SUBJECT: **NEW VEHICLE DEMONSTRATION / DELIVERY HOLD
 Compliance Recall 23C16**
 Certain 2021 - 2023 Model Year Bronco Vehicles
 Seat Belt Latch Plate Access

CERTAIN 2021-2023 MODEL YEAR BRONCO VEHICLES — SEAT BELT LATCH PLATE ACCESS

FIGURE 1

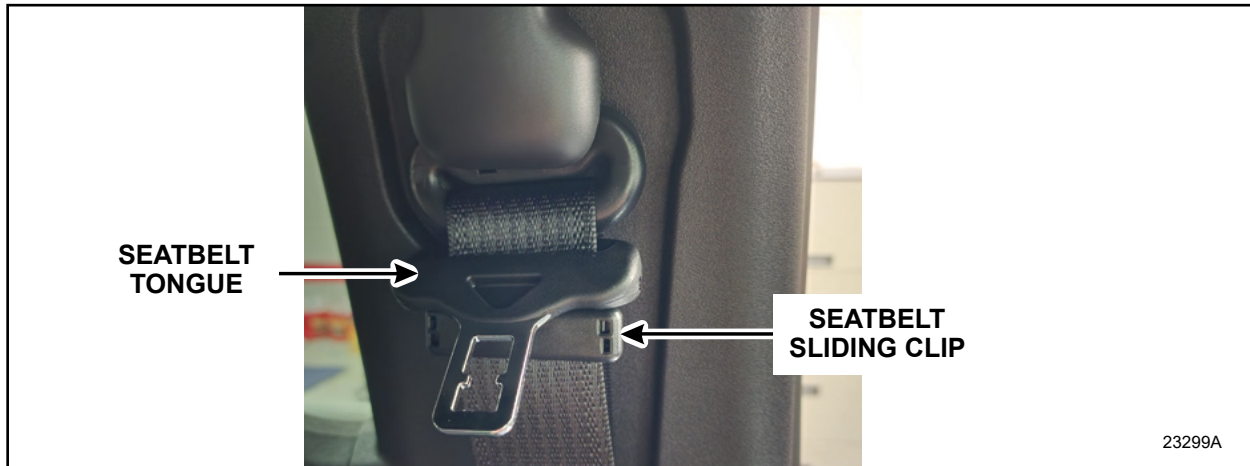
1. Take the two pieces of the clip, put them over the seatbelt webbing and snap the pieces together using your thumb and forefinger until the clip clicks into the correct position. The correct position for this sliding clip is below the seatbelt tongue and located at the highest position on the seatbelt webbing as shown in Figure 1. Install the sliding clip on the front driver and passenger side seatbelts. See Figures 1 and 2.
